SERVICE NOTICE

SUBJECT: CREW DOOR BUMPERS

EFFECTIVITY: KODIAK 100 Series Aircraft Serial Numbers: 100-0001 through 100-0077

Service Notice: SN13-02

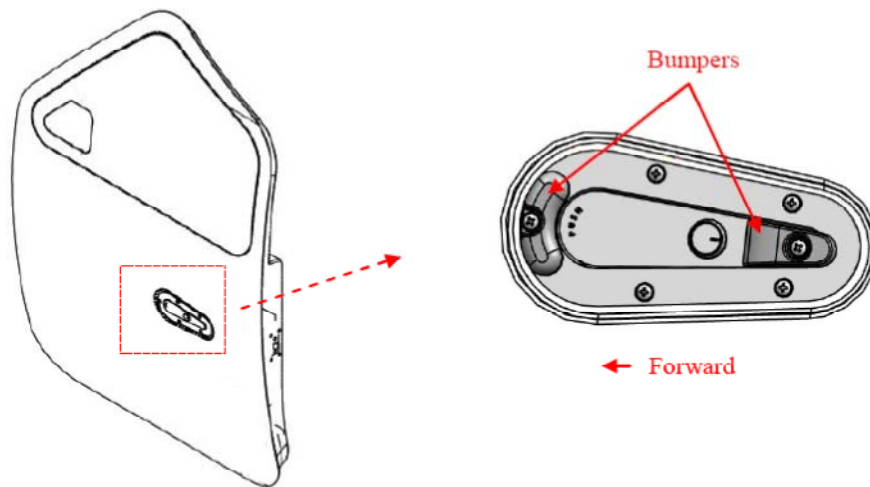
This Service Notice is to make customers aware of the option to install the new Crew Door Bumpers into the handles of the KODIAK 100 aircraft in order to prevent cosmetic damage to the aircraft.

Quest is proud to announce the availability of the new Crew Door Bumpers (**FSI-048**).
